Memo

Date: May 21/10
To: City Manager
From: Community Sustainability Division
File No: Z10-0032 **Applicant:** Westnedge, Wallace David
At: 450 Donhauser Road **Owner:** Westnedge, Wallace David
Purpose: TO REZONE FROM THE RU1 - LARGE LOT HOUSING ZONE TO THE RU1s - LARGE LOT HOUSING WITH SECONDARY SUITE ZONE TO ALLOW A BASEMENT SUITE WITHIN THE EXISTING PRINCIPAL DWELLING
Existing Zone: RU1 - Large Lot Housing
Proposed Zone: RU1s - Large Lot Housing with Secondary Suite
Report Prepared by: Luke Turri

Date: May 6, 2010
File No.: Z10-0032
To: Planning & Development Services Department (LT)
From: Development Engineer Manager (SM)
Subject: 450 Donhauser Road – Lot 8, Plan 8606, Sec. 26, Twp. 26, ODYD

Westnedge
450 Donhauser Road New Basement Suite

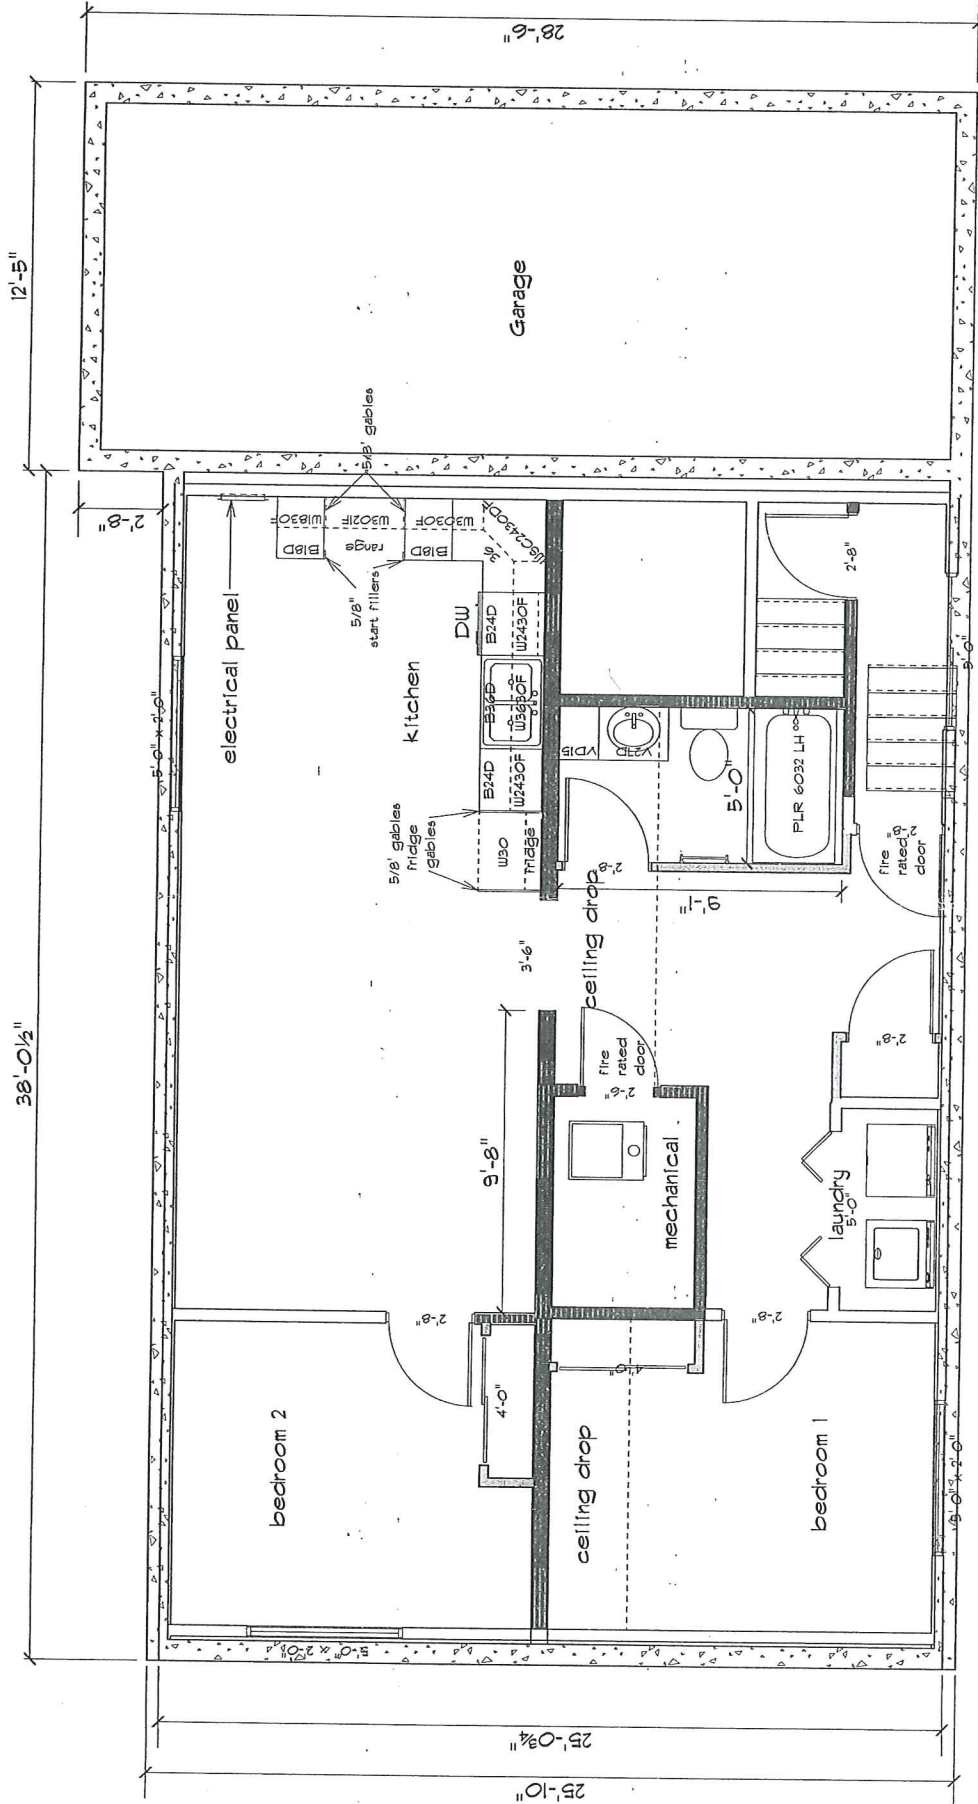
Operable bedroom windows required as per BCBC 2006. Access to exterior from the basement suite is required to go thru a door operating on vertical hinges (sliding patio doors are not allowed). BP application to indicate the method of fire separation between suite and main dwelling. Fire rating of access to exit required on main floor around stairwell to basement. The mechanical room walls are required to be fire rated and have a self closing, weather striped, fire rated door assembly. Range hood above the stove and the washroom fan to vent separately to the exterior of the building. The size of the penetration thru the fire separations for these elements are restricted by BCBC 2006. The mechanical system is recommended to be separated from the main dwelling.

Requirements of Section 9.36, Secondary Suites, of the BCBC 2006 are to be met. Fire separations are required between the suite and the main home as per BCBC 2006.
